FCC ID: VD4Q53R6
IC ID: 7162A-Q53R6
Model Numbers: Q51, Q52, Q53R6, Q70, Q71

Request for Class II Permissive Change

FIGURE 1 - PHOENIX CONTACT ANTENNA

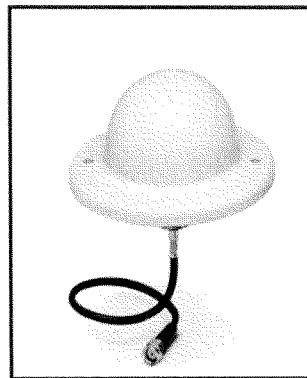
1. Addition of one antenna to the supported antenna types associated with this certification.

New antenna details:

Manufacturer	Model	Type	Gain
Phoenix Contact	RAD-ISM-2400-ANT-VAN- 3-0-SMA	Omni-Directional	3 dBi (nom)

Note: The new antenna is for use with the 2.4GHz antenna port only.

This antenna has been tested with the certified device to ensure that the device remains in compliance with the FCC and IC rules for spurious emissions and RF exposure. The antenna is to be added to the certification in compliance with part (1) of the FCC's permissive change policy (KDB 178919).
